# SAKURA NOVI JZ19-31

# SAKURA NOVI JZ19-31 WITH REZONING 18.732

# PLAN REVIEW CENTER REPORT

Revised: Rezoning Request from OSC (Office Service Commercial), OS-1 (Office Service), and I-1 (Light Industrial) to TC-1 (Town Center - 1) with a Planned Rezoning Overlay (PRO)

**Figure 1**. City of Novi Regulated Wetland & Woodland Map (approximate project boundaries are shown in red). Regulated Woodland areas are shown in green and Regulated Wetland areas are shown in blue.

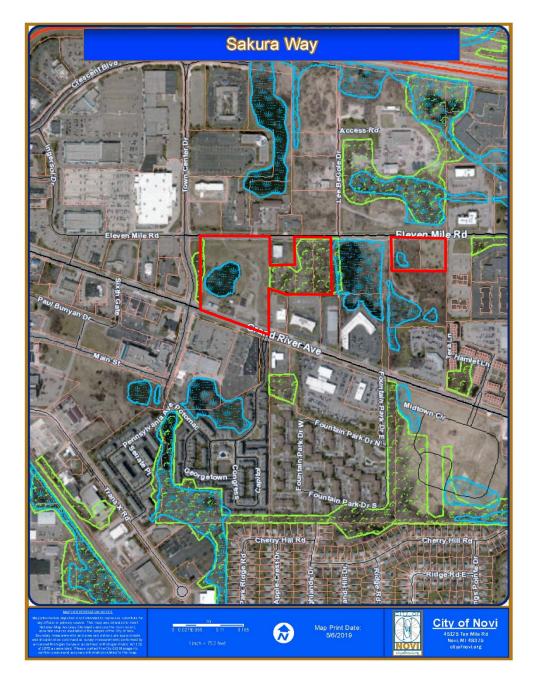
ECT's in-office review of available materials included the City of Novi Regulated Wetland/Watercourse and Regulated Woodlands maps (see Figure 1, attached), USGS topographic quadrangle map, NRCS soils map, USFWS National Wetland Inventory map, and historical aerial photographs. The City of Novi Regulated Wetlands Map indicates one (1) area of existing wetland (i.e., pond/Wetland 2) on the westernmost parcel (50-22-23-126-006) as well as a small area of regulated wetland on the eastern portion of the project properties (i.e., Wetland "5" on Parcel No. 50-22-23-226-021).

The majority of the central portion of the project site is indicated as City-Regulated Woodland on the City's Regulated Woodland Map (see Figure 1, attached). There is also area designated as Regulated Woodland along the western edge of the project property. The majority of the area that contains the open water

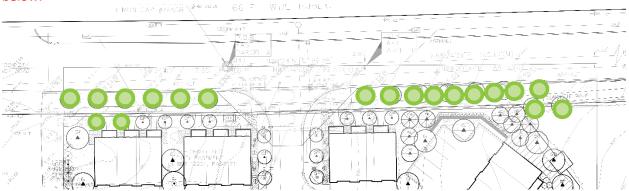
Please spread the provided greenbelt trees across the site more and add two more canopy trees in order to remove the landscape deviation.

We will provide 20 Deciduous Canopy trees along the commercial stretch of 11MR, spaced 30' O.C. east of the entry drive and 28' O.C. west of the entry drive, as shown below:

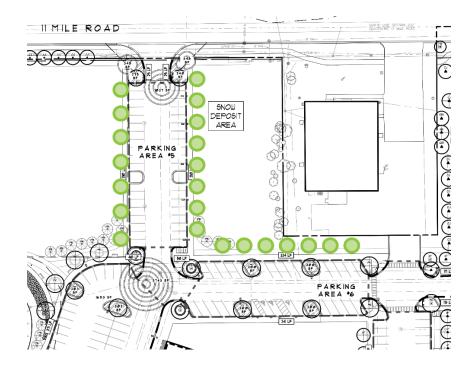
Commercial: Based on the vehicular use area calculations provided, a total of 7,026 of interior landscape area and 35 canopy trees are required. A total of 7,032sf of area and 27 trees are

provided, some in islands with less than 200sf per tree. These shortages in interior landscape area and trees require landscape deviations. They are not supported by staff. Please see the landscape chart for a detailed explanation.

We are proposing interior parking lot landscaping that exceeds the required square footage for the project by 7 sf. Landscape islands which have a minimum dimension under 10 lf, or which are under 200 sf and are not directly contiguous with larger landscape areas have not been included in this calculation. All ordinance-conforming islands will also be planted with canopy trees per the city ordinance.

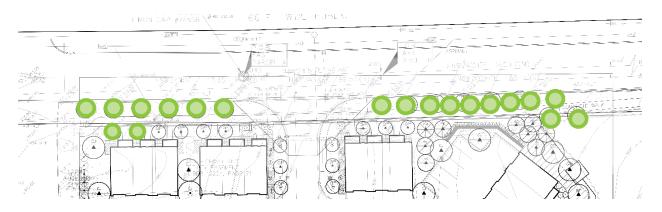
Please add as much foundation planting area around each building as possible to lower the extent of the deviation.

We are proposing additional building foundation landscape planting areas which meet some, but not all, of the requirements stated in the city ordinance. Per Section 5.5.3.D.g, *"With respect to projects within the TC and TC-1 districts, the Planning Commission may waive the 8 foot width calculation requirements if significant additional planting and/or decorative paving or amenities are added adjacent to the building." The applicant will be appealing to the Planning Commission to waive the 8' calculation requirement as described in the ordinance.*
